INTERNATIONAL STANDARD ISO 1161 : 1984
TECHNICAL CORRIGENDUM 1

Series 1 freight containers — Corner fittings — Specification

TECHNICAL CORRIGENDUM 1

Figure 2 — Top corner fitting — Dimensions in inches
(see clause 3)

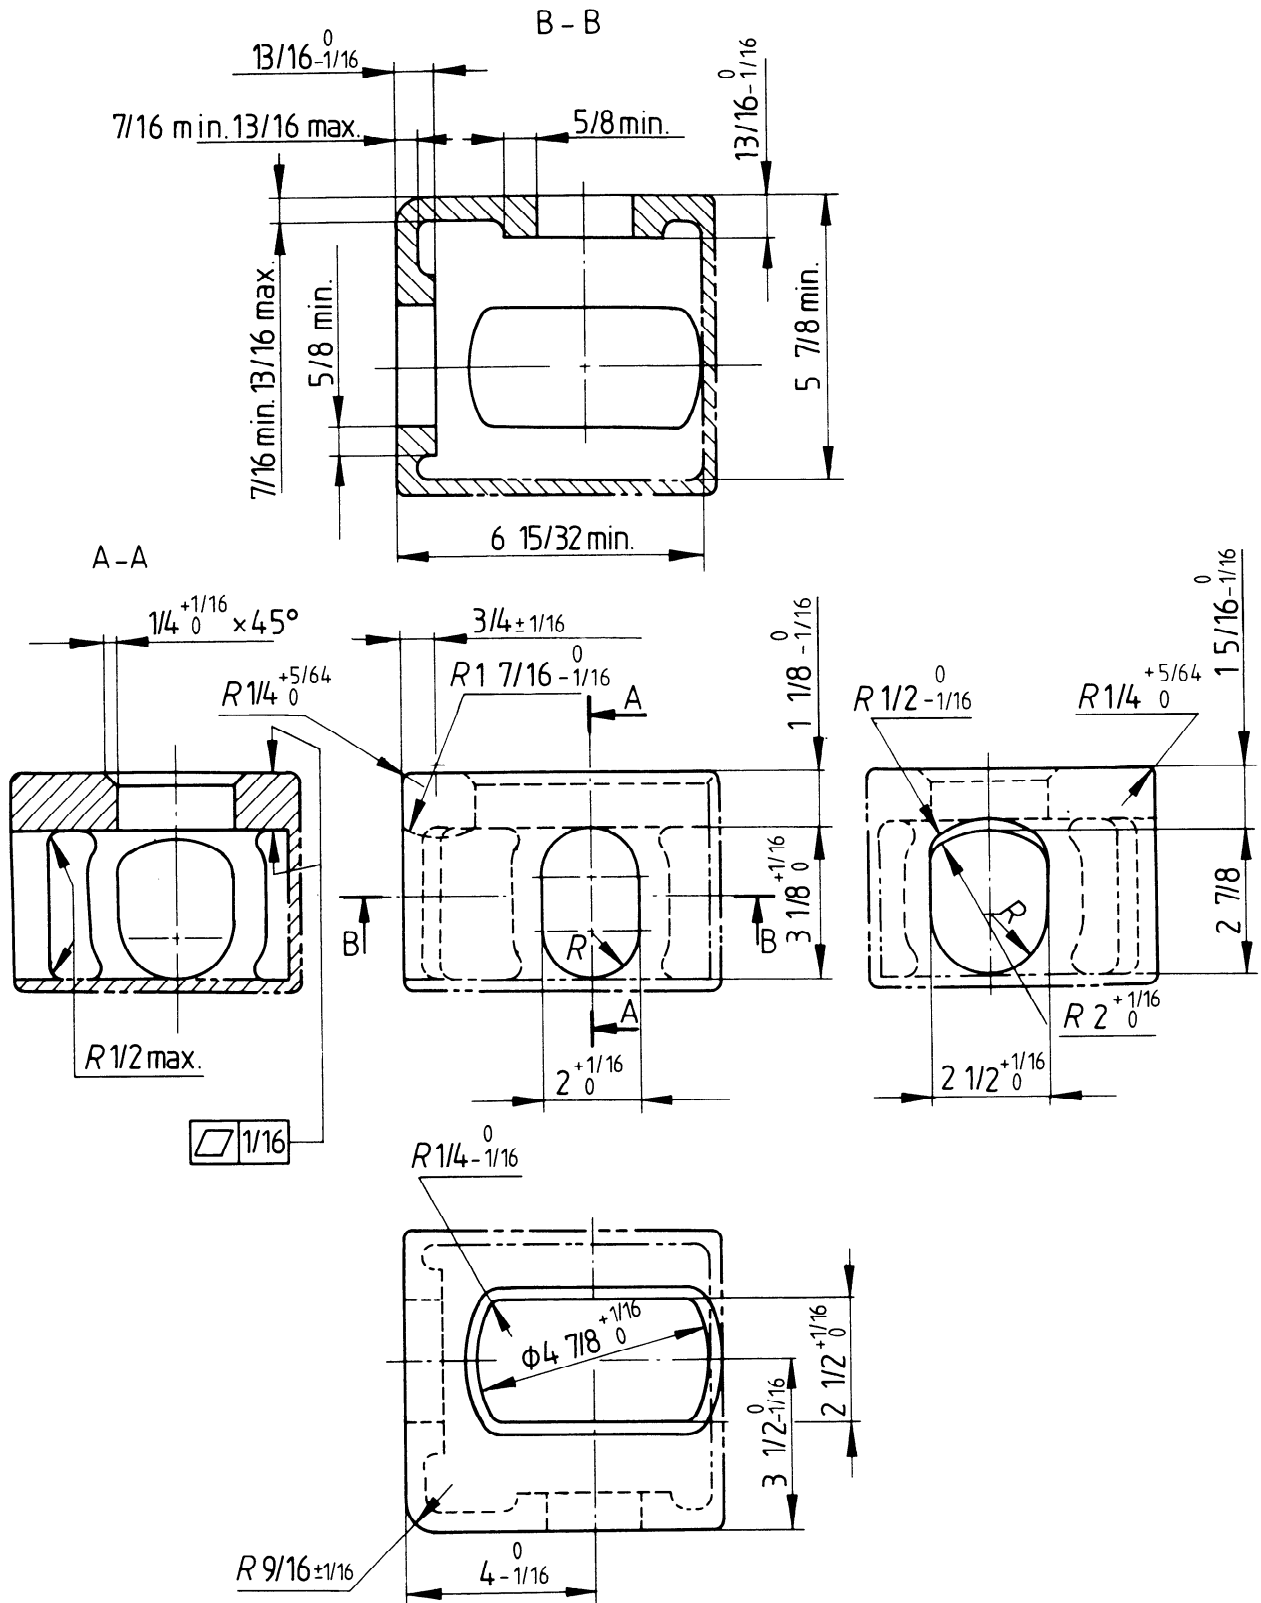
Replace the existing figure 2 with the following figure 2. (In the front view, $1\frac{1}{8} + \frac{1}{16}$ has been changed to $1\frac{1}{8} - \frac{0}{16}$.)
